Comments to the Virginia Water Control Board, 12/11/17
Rick Webb, Program Coordinator
Dominion Pipeline Monitoring Coalition

Rick Webb, Program Coordinator, Dominion Pipeline Monitoring Coalition (DPMC)

Exhibit 3

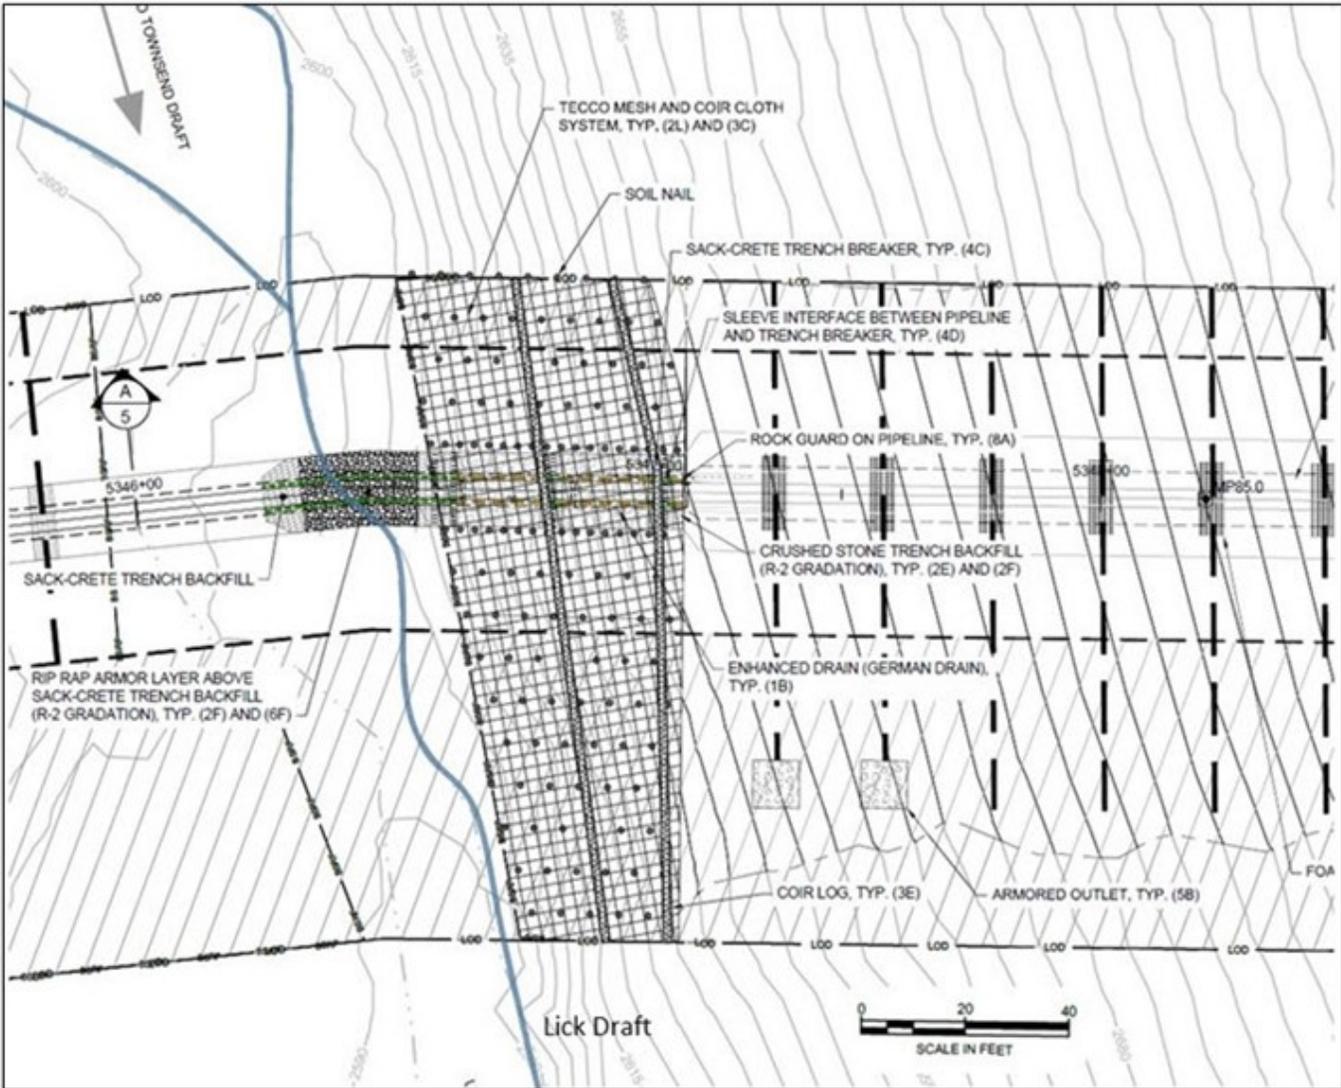
Dominion proposes to hold the steep foot slope above Lick Draft in place by installing heavy-gauge steel wire mesh fastened to the mountainside with 8 to 15-foot steel nails installed with epoxy in 6-inch diameter holes drilled into bedrock. (*See endnote on Dominion pipeline slope failures.*)

- In what sense can this be considered restoration to natural conditions?
- Will the steel mesh be corrosion proof? How long will it last?
- Will this approach to slope stabilization maintain preexisting runoff characteristics as required by stormwater regulations?
- How will this installation, immediately adjacent to a stream and a narrow riparian corridor, affect wildlife?
- How *many* of the *many* similar steep-slope locations in the pipeline path will be subject to this extreme measure?
- What will be the cumulative effect of multiple such installations in single watersheds?

Dominion also proposes to use concrete to backfill where the pipeline is buried in a trench across Lick Draft. This too, raises questions:

- How can this be considered restoration to natural conditions?
- Who is responsible for restricting construction during high-flow conditions when concrete pollution, which is toxic to aquatic life, will be impossible to avoid?
- What affect will a permanent concrete barrier across a stream bed have on the morphology and ecological functioning of the stream?
- Who will review the inevitable requests for waivers of time-of-year restrictions for construction activity in native brook trout streams?
- How *many* of the *many* mountain streams in the pipeline path will be subject to this extreme measure?
- What will be the cumulative effect of multiple such stream crossings in single watersheds?
